Subject: Re: WRITTEN SUBMISSION Hofbauer: LETTER OF OBJECTION 231 Whale
Beach Road Whale Beach 2107 REV 2021/0034

SUBMISSION: HOFBAUER
a written submission by way of further objection to REV 2021/0034

231 Whale Beach Road Whale Beach 2107
REV 2021/0034

Section 8.2(1A) Review of Determination - Review of Determination of Application DA2020/0442 for demolition works and construction of a Mixed-Use Development comprising Shop Top Housing and retail premises, with associated carparking, landscaping and strata subdivision

Marked-up Roof Plan: Zone in excess of 8.5m building height: the excessive height above 8.5m is not 'minor' and fails LEP 4.3 2D [a], and fails the objectives LEP 4.3 [1] [a] desired character of locality, [b] compatible with neighbours, [c] overshadowing, and [d] view.

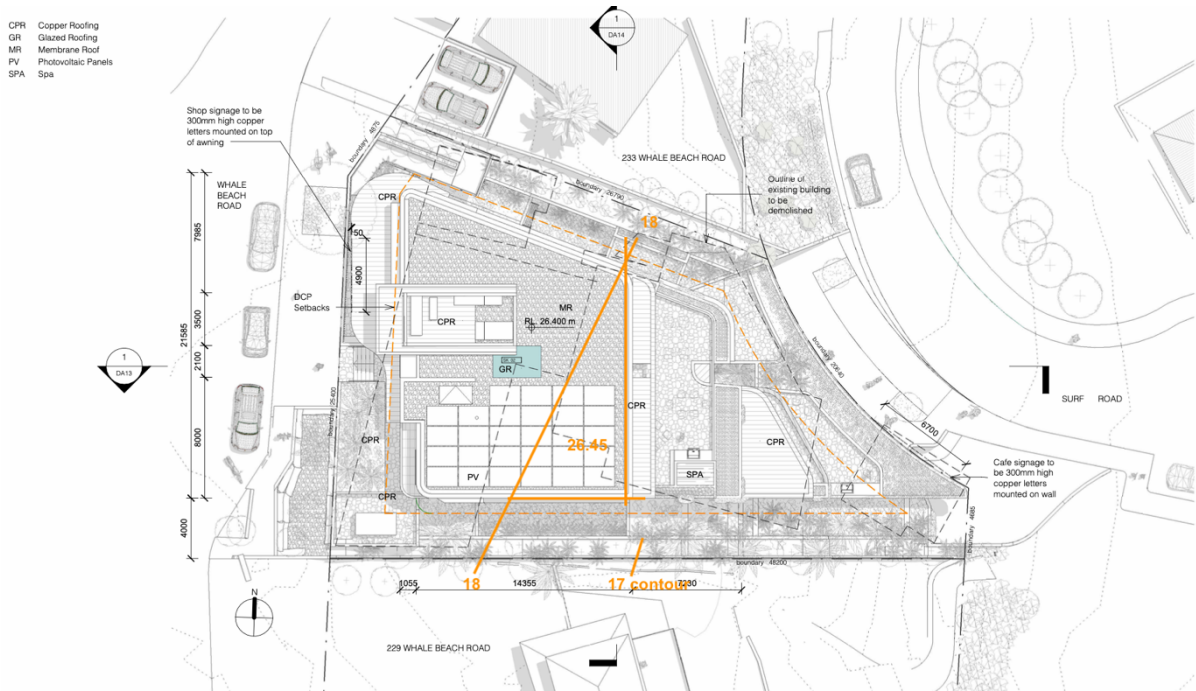
We are disturbed to find a misrepresentation of Heights of Buildings with the *envelope blankets* clearly not aligning with the Registered Surveyors spot levels on the survey.

The Building Height is 9.5m, representing a 12% non-compliance to the 8.5m height. No variation has been sort under Clause 4.6.

The south-east corner of the Level 4 is positioned well above the 8.5m building height, contrary to the Applicants drawings. The excessive height extends along the southern boundary at Level 4 by up to 8m in length, and extends across the entire eastern 16m edge of the proposed roof.

The Registered Surveyors drawings show the 17m contour and a multitude of spot levels between 17m and 18m along the proposed development's southern flank.

The Applicants Height Blanket drawings are unfortunately false and misleading.

The excessive roof zone above 8.5m is a triangular section covering an area of c 65sqm of the south-east corner of Level 4. It is this zone that we contend is unacceptable.

We contend that the excessive height above 8.5m is not 'minor' and **fails LEP 4.3 2D [a]**, and fails the objectives **LEP 4.3 [1] [a] desired character of locality, [b] compatible with neighbours, [c] overshadowing, and [d] view.**

1. Lower the entire built form by 1m. Proposed south-east corner of the roof, sits adjacent to the RL 17.0 Contour. Reduce the Roof Parapet to RL 25.5 to maintain 8.5m building height. Alternatively remove the non-compliant zone above 8.5m building height by greater terracing and a reduced upper level floor plate.

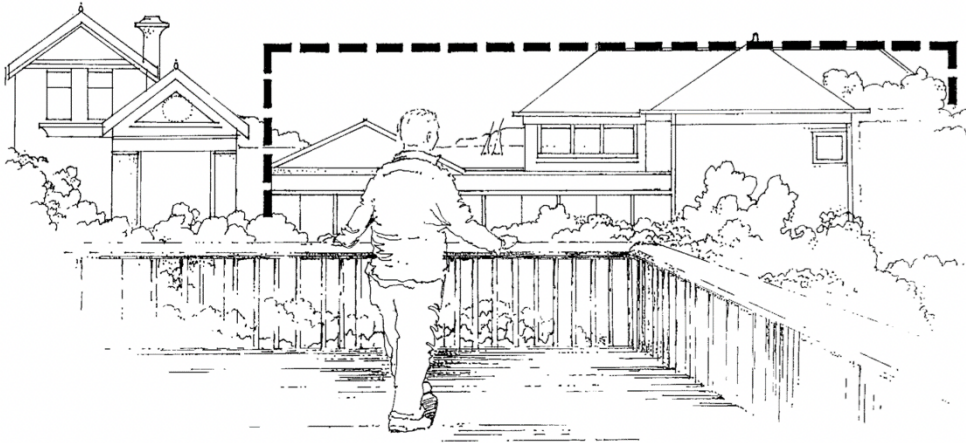
As the proposed development does not comply with outcomes and controls, that are the most relevant to visual impacts, greater weight would be attributed to the effects caused.

In our opinion the extent of view loss considered to be **moderate**, in relation to the views from our living rooms and living room deck of our dwelling, particularly to the east. The view is from a location from which it would be reasonable to expect that the existing view, particularly of the water could be retained especially in the context of a development that does not comply with outcomes and controls.
